Title: UNALink AG3335M

Usage: Link Module for Una Watch with AG3335M GNSS Receiver

Modifications Record:

1.0)	Design Completed	17/04/2025	Lewis Allison
1.1)	Engineering Change Note 1	14/08/2025	Lewis Allison
1.2)	Engineering Change Note 2 (BOM Only)	18/11/2025	Lewis Allison
1.3)	Engineering Change Note 3	04/02/2026	Lewis Allison
1.4)	Engineering Change Note 4 (BOM Only)	05/05/2026	Lewis Allison

02 - Main Board Interface

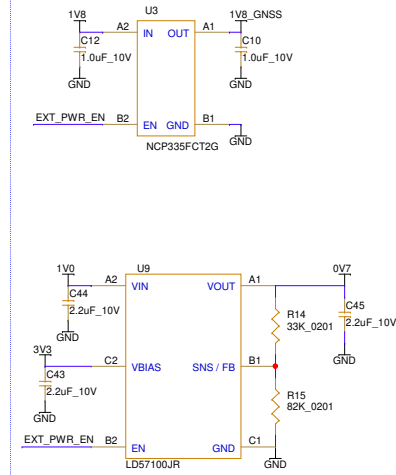
ECN 3:
RTS, CTS removed.
WAKE_GNSS_TO_HOST connected to J1.1
WAKE_HOST_TO_GNSS connected to J1.4
RTC_EINT moved to J1.3

ECN 1:
TP15 removed.
TP8 changed to 0V7.

ECN 3:
TP10, TP13 & TP14 removed.

ECN 3:
Added GND Pad.

03 - GNSS

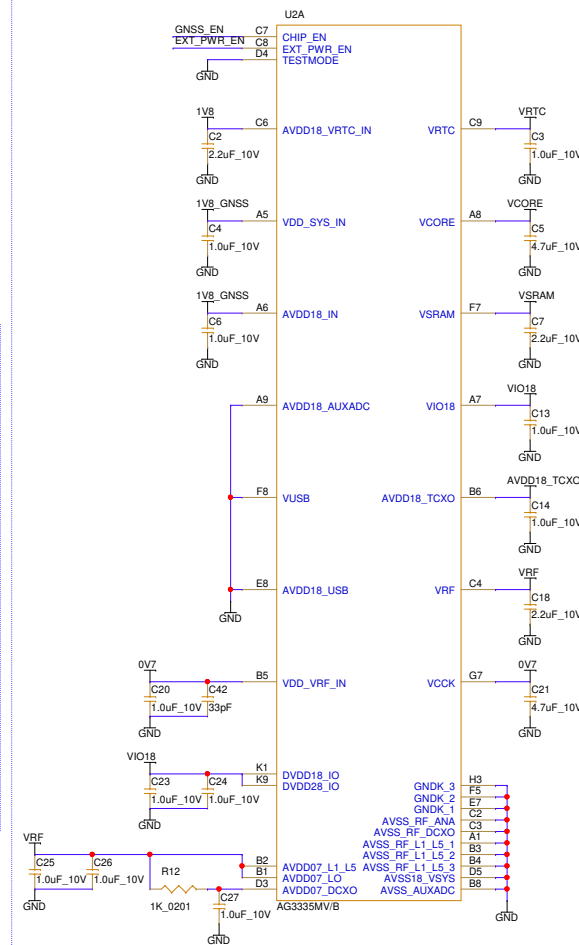
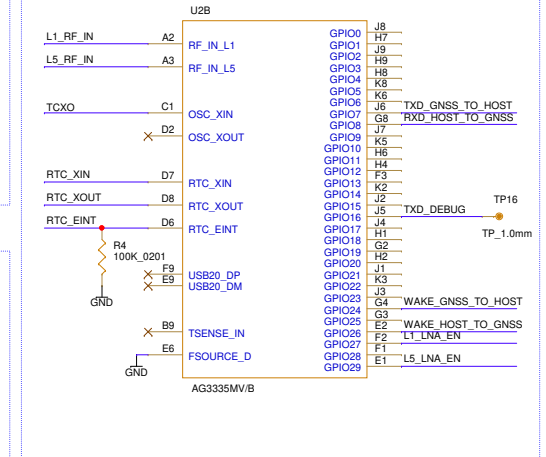
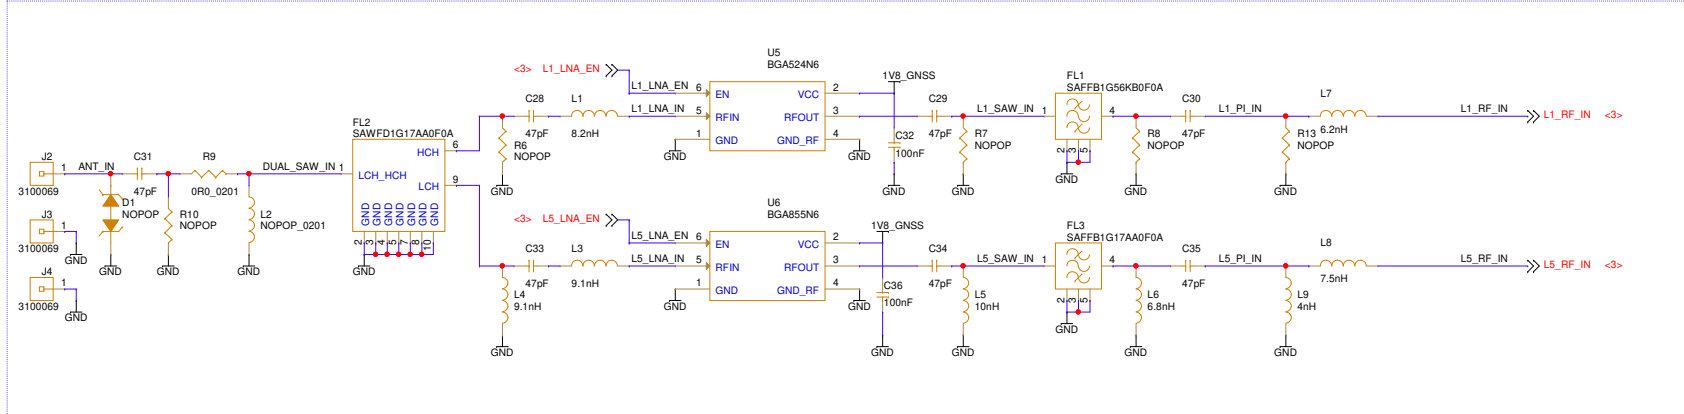
ECN 1:
U4 removed.
C15 and C16 removed.
U9 added (LD57100JR).
C43, C44 and C45 added (2.2uF).
R14 added (33K).
R15 added (82K).

ECN 1:
U2 pins A9, F8 & E8 connected to GND.
C11, C17 removed.
VDD_RF_IN and VCK connected to 0V8.
R12 added.
C42 added.

ECN 3:
R1 removed.
R2 removed, TESTMODE connected to GND.

ECN 1:
Connected G1 pin 1 to GND.

ECN 2:
R3 replaced with 1nF.

ECN 3:
RTS, CTS removed.
WAKE_GNSS_TO_HOST, WAKE_HOST_TO_GNSS added.
R5 removed, FSOURCE_D connected to GND.
TXD_DEBUG and TP16 added.

05 - IMU & Magnetometer

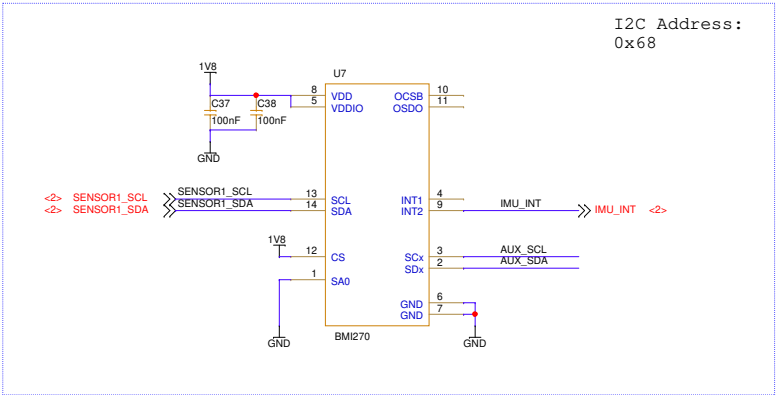
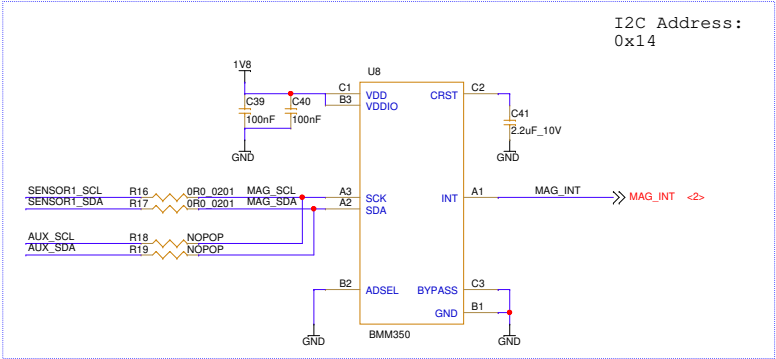
ECN 1:
Routed AUX I2C option.
Added R16 & R17 (0R0).
Added R18 & R19 (DNF).
